ADDENDUM NO. 1

**CITY OF SAN ANTONIO
CAPITAL IMPROVEMENTS MANAGEMENT SERVICES DEPARTMENT**

PROJECT NAME: **CULEBRA 58F PHASE IIB**

CIMS PROJECT NO.: **40-00050**

FIGURE 1
ENVIRONMENTAL AREA OF CONCERN 1

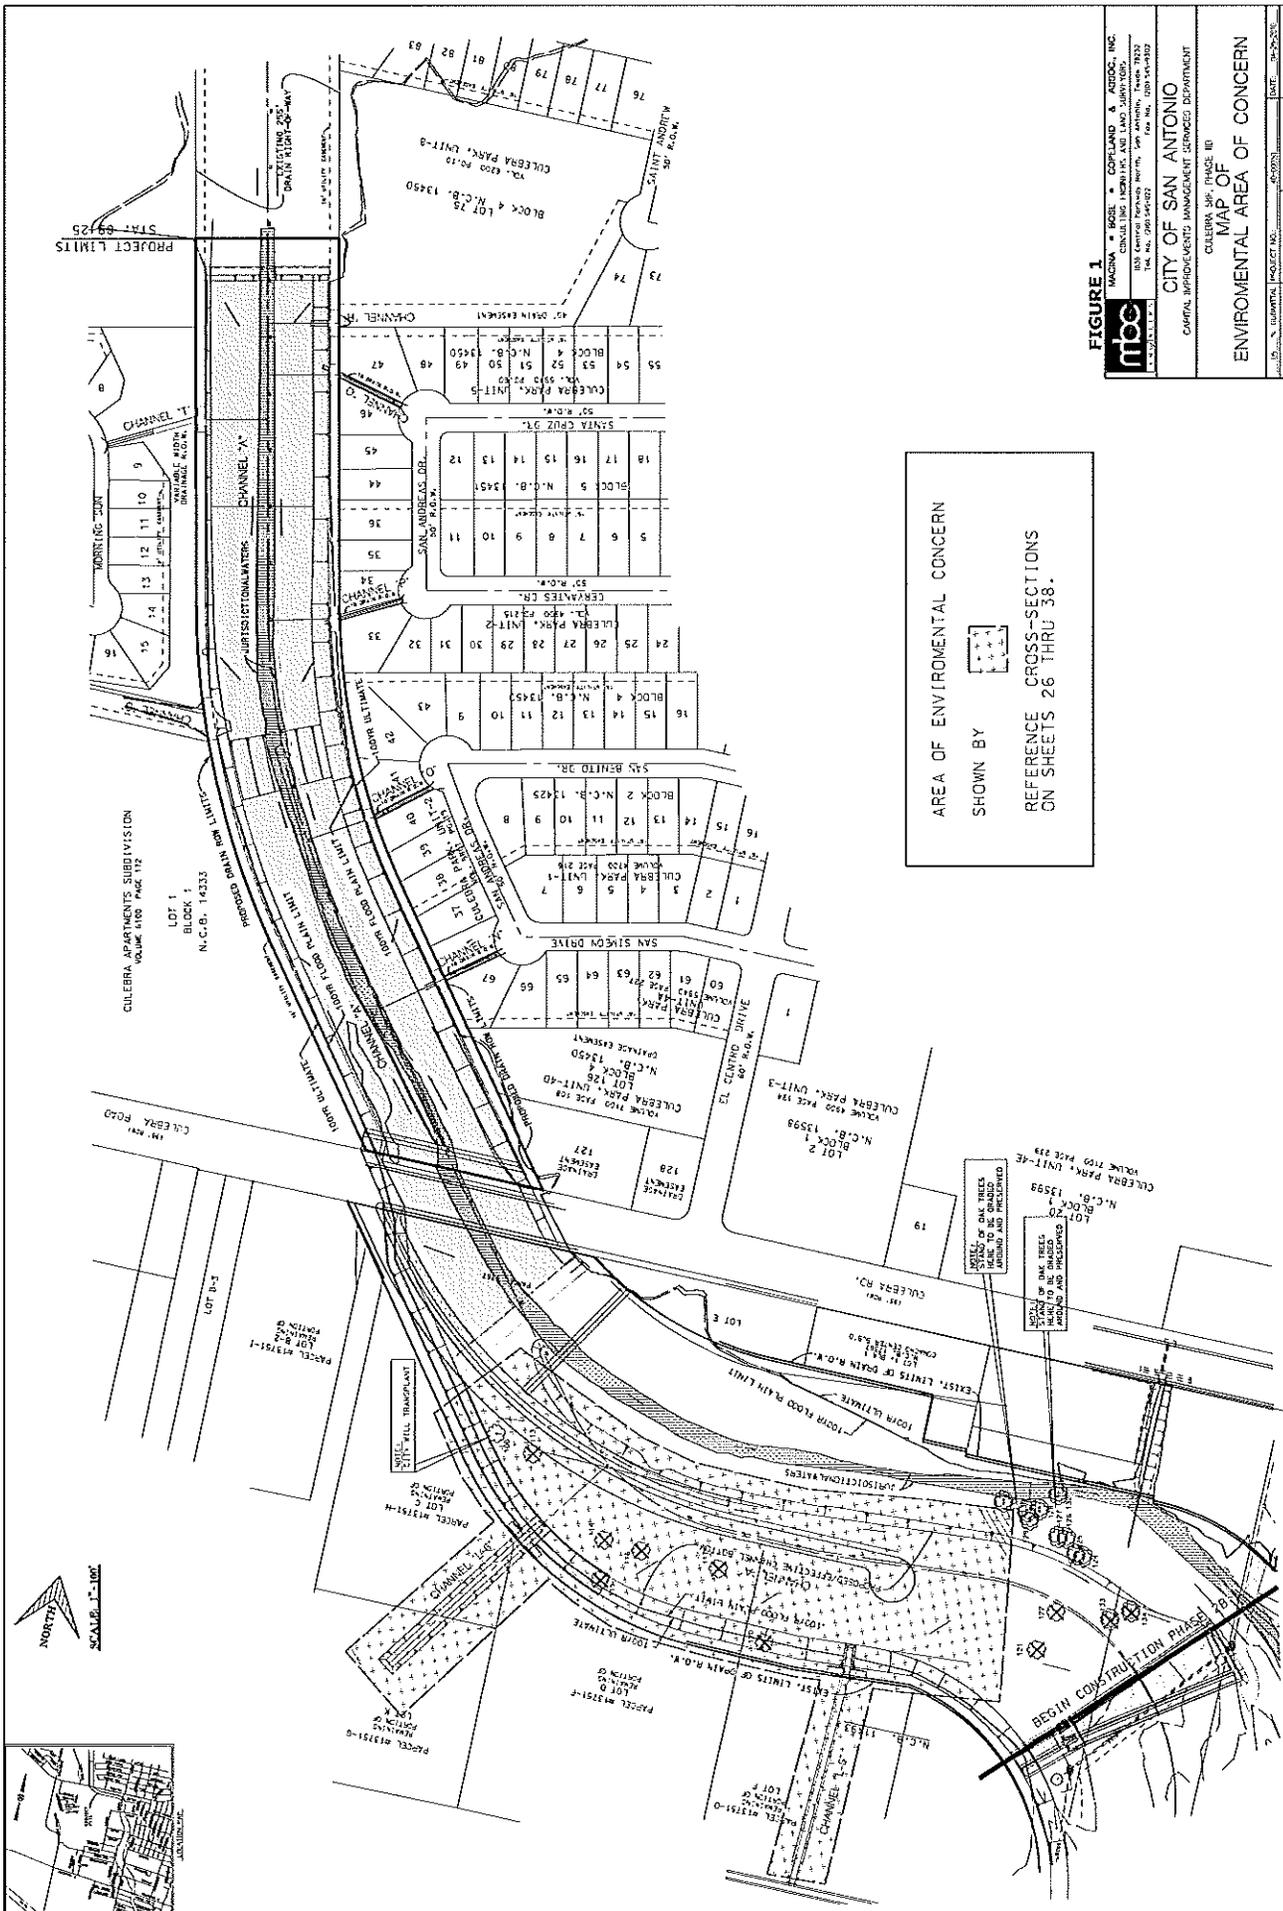
A review of the subsurface investigations and 95% design plans dated February 8, 2011, revealed one impacted area identified as Area of Concern (AOC) 1, located along the proposed drainage improvements between STA 58+00 and 68+75 along Zarzamora Creek. There is potential to encounter waste debris and lead impacted soils at this AOC southeast of Culebra Road (see figure 1).

The specific area, station numbers, cross-sections, and locations of the impacted area are identified in Figures 1 and 6A-6D. Specific procedures required for AOC 1 are listed below:

The lead impacted media generated during construction in AOC 1 shall be managed by reusing as much of the impacted material as possible along Zarzamora Creek between STA 58+00 to 68+75. The waste debris should be removed from the excavated soils and disposed at a licensed TCEQ landfill. Should there be excess soils from the excavation that cannot be used within the project area; these soils must be disposed of at a licensed TCEQ landfill. It is anticipated that soils from surface to a maximum depth of 11.5 feet bgs or proposed drainage excavation depth are to be considered suspect soils and would require management and/or disposal at a licensed landfill. The Contractor will be required to coordinate and notify the City's representative 48 hours in advance prior to beginning work in AOC 1.

FIGURE 2
OPEN EXCAVATION RUN-ON PREVENTION

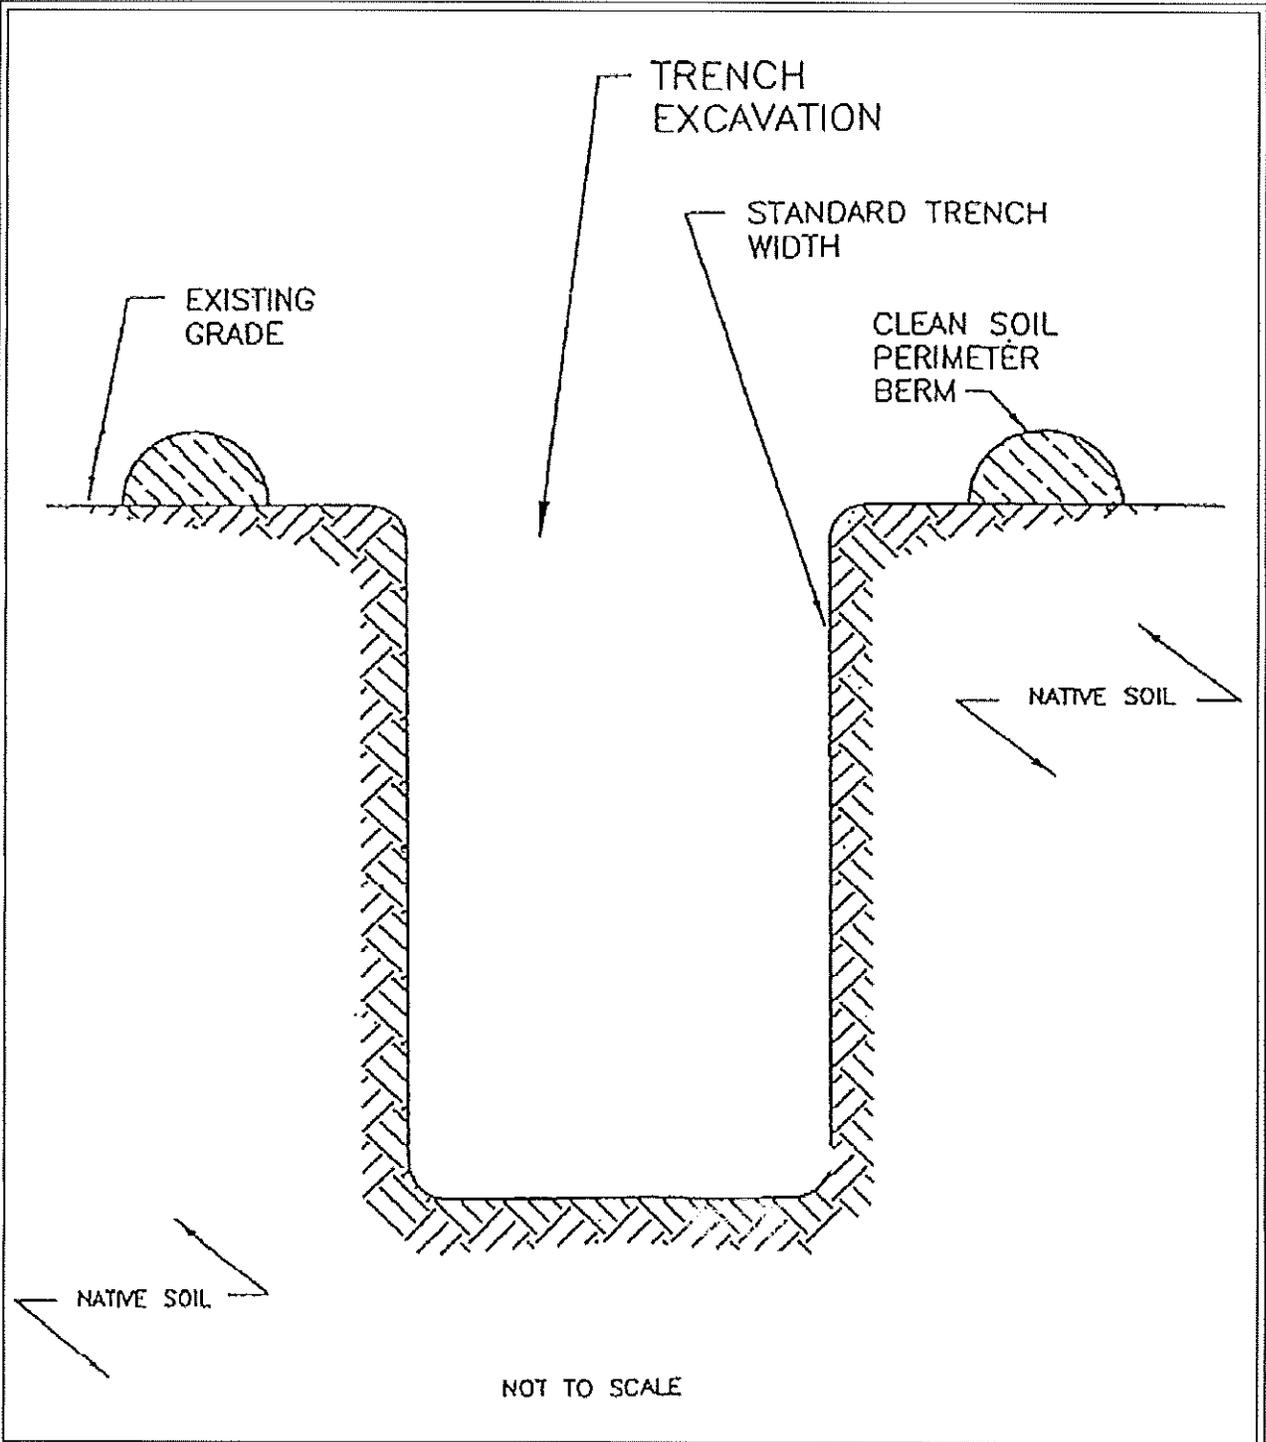
During the course of the project, water, either stormwater or groundwater, may accumulate in the excavations in AOC 1. It is in the best interest of the Contractor to provide soil berms or other protective measures around the excavated trench to prevent water intrusion. A figure depicting protective measures for stormwater intrusion is shown on Figure 3, Open Excavation Run-on Prevention. In the event that removal of water from the excavation is necessary, proper characterization and disposal is required by the Contractor's environmental consultant. Specifically, the consultant shall collect at a minimum one water sample from each identified impacted area. This water sample shall be analyzed for lead. Laboratory analyses of sample(s) collected must be conducted in accordance with standards of the Environmental Protection Agency (EPA) methods. Upon approval by the Environmental Management Division of CIMS, non-impacted water may be discharged into the storm sewer system per the Texas Pollutant Discharge Elimination System (TPDES) permit. Impacted water must be removed and disposed of in accordance with all Federal, State, and Local regulations at the Contractor's expense. The Contractor's consultant shall be responsible for submitting analytical data and disposal documentation to the City of San Antonio, Capital Improvement Management Services Department\Environmental Management Division. Upon approval, the Contractor will be directed on the appropriate disposal methods.
